# AUI-C2C TBD Removal

Comments 548-551, 554-556

H. Heck, TE Connectivity  
2025.01.21

# Objective

### COM vs I<sub>ldd</sub>

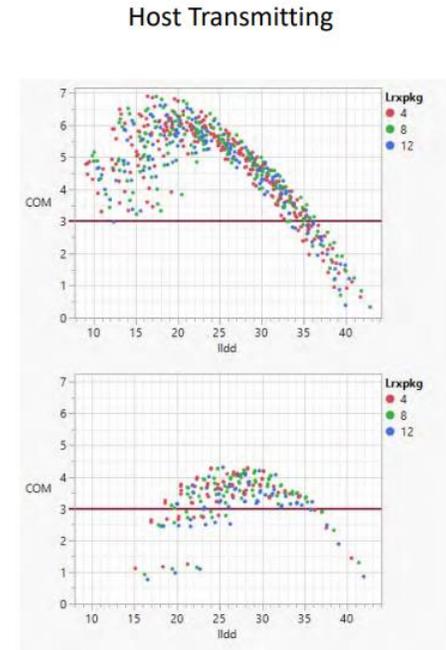
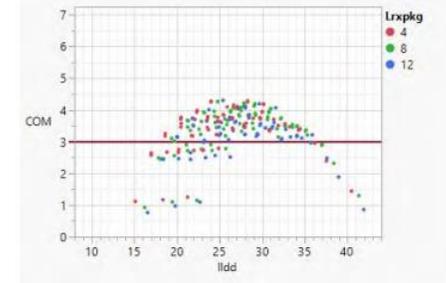
- Channel ILdd is TBD in Table 176C-5 and in 176C.5.2.
- 176C.5.2 also has a TBD frequency mask equation and plot.

**176C.5.2 Channel insertion loss (recommended)**  
The recommended channel insertion loss, I<sub>ldd</sub>, is 32 dB at 53.125 GHz.

heck\_3dj\_01a\_2407, slide 7<sup>7</sup>
